Access Compliance Report

Public Rights-of-Way

(Curb Ramps)

| Intersection ID: 48767 | Main Street: TURNING_WHEEL_DR | Cross Street: MINITREE_LN | Location: NW |

| ADA ID: DEB91ACF23C7 | Ramp Type: PerpDiag | Initial Pass/Fail: Fail | Overall Compliance: No |

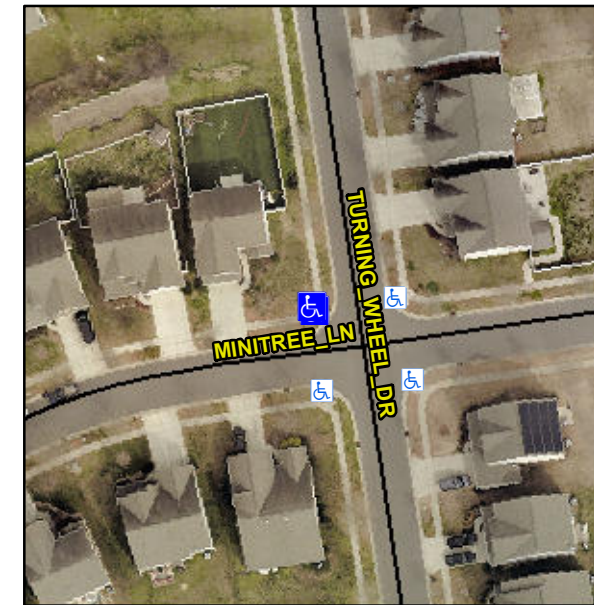
R304.5.1

| Compliance | Description | Data | Compliance | Description | Data |
|------------|-----------------------|------|------------|-----------------------------|------|
| No | Ramp Width (in) | 47.5 | Yes | Ramp XSlope (%) | 0.6 |

Remove & Replace Curb Ramp With Two New Directional Ramps or Equivalent.
